ADDENDUM COVER SHEET

Addendum No. 2

Renovations of the East Schuylkill River Wall

Philadelphia Redevelopment Authority

PROPOSED REPAIR TYPICAL SECTION

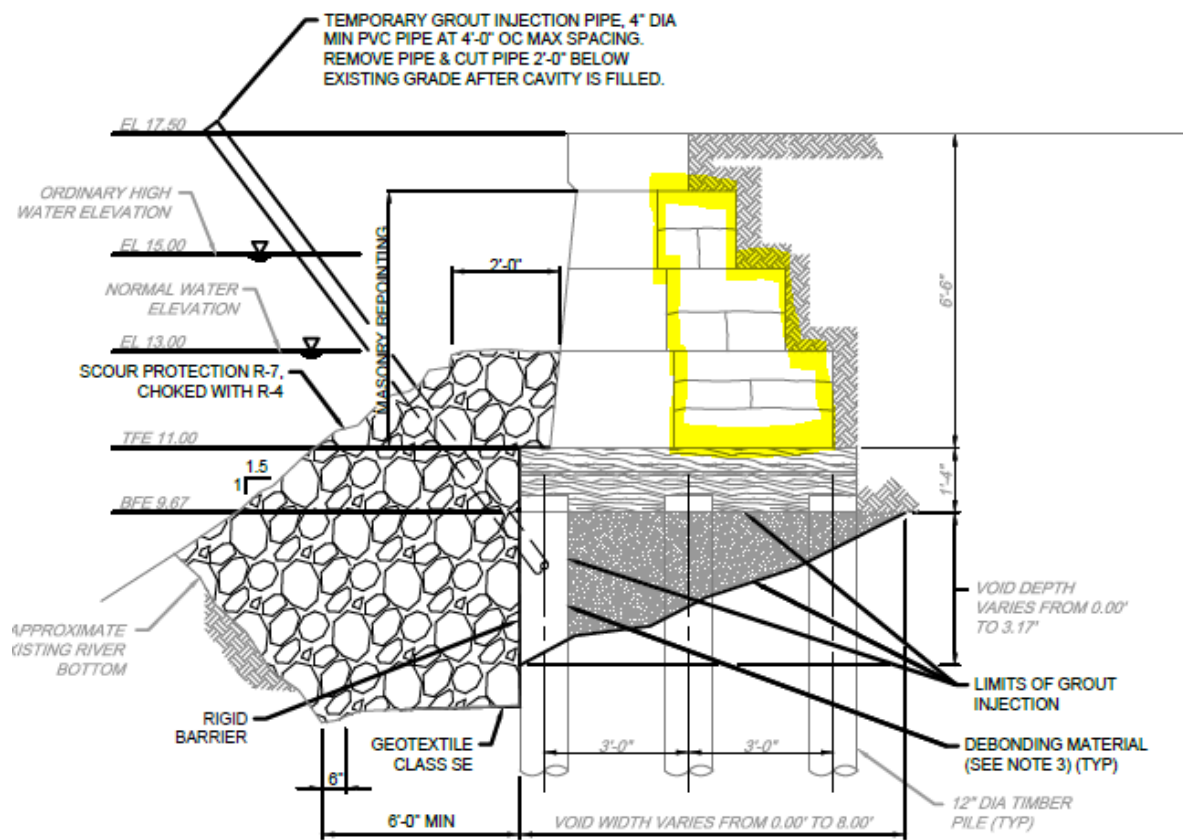
2. Can the engineer or owner please advise on what is behind the existing Stone Walls?

RESPONSE: *The original design plan of the existing wall can be provided in Addendum No. 2. The highlighted portion is also stone with compacted backfill behind it, based on the available existing information.*
